SERVICE BULLETIN

SB-050224-A

ID NUMBER & REVISION: SB-050224-A
SUBJECT: (Mandatory) Rudder Pedal Cable Chafing
RELEASE DATE: 08 July 2024
EFFECTIVE DATE: 08 July 2024
SUPERSEDES NOTICE: N/A
AIRCRAFT AFFECTED: **MAKE & MODEL:** ICON A5
SERIAL NUMBERS: 00001-00062, 00064-00083, 00085-00100, 00102-00163, 00165-00184, 00186-00190, 00192, 00194-00198, 00199, 00201, 00204, 00205

Figure 1. Rudder Pedal Cable Chafing on Retainer Bracket

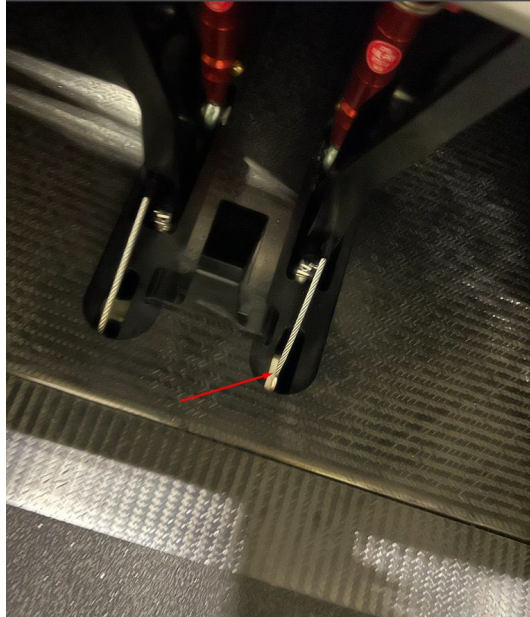
It has been identified that there may be potential for chafing of the rudder pedal cables when the pedals are in the aftmost position.

2. Permissible to remove the aft floorboard panels from the aircraft per the Maintenance Manual for improved visibility.
3. Move the rudder pedals, in their full range of motion, paying close attention to AFT Recessed Floor Closeout Panel (**Figure 2**) and Floor Closeout Retainer Bracket (**Figure 1**). The condition is most evident with the pedals in the aftmost position. Using a sharpie pen, mark any interference present on AFT Recessed Floor Closeout Panel and/or Floor Closeout Retainer Bracket. The interference will be removed in a subsequent step.

3. For the floor close out retainer bracket:
 - c. Permissible to remove up to .400" from the bracket; however, material may have previously been removed. Measure the bracket to ensure that the total amount of material removed does not deviate more than .400" from what is shown in **Figure 3**.

- d. Minimally blend the affected areas to achieve a blend ratio 20:1 to allow clearance. From the edge, maintain a maximum blend depth of 0.100 inch.
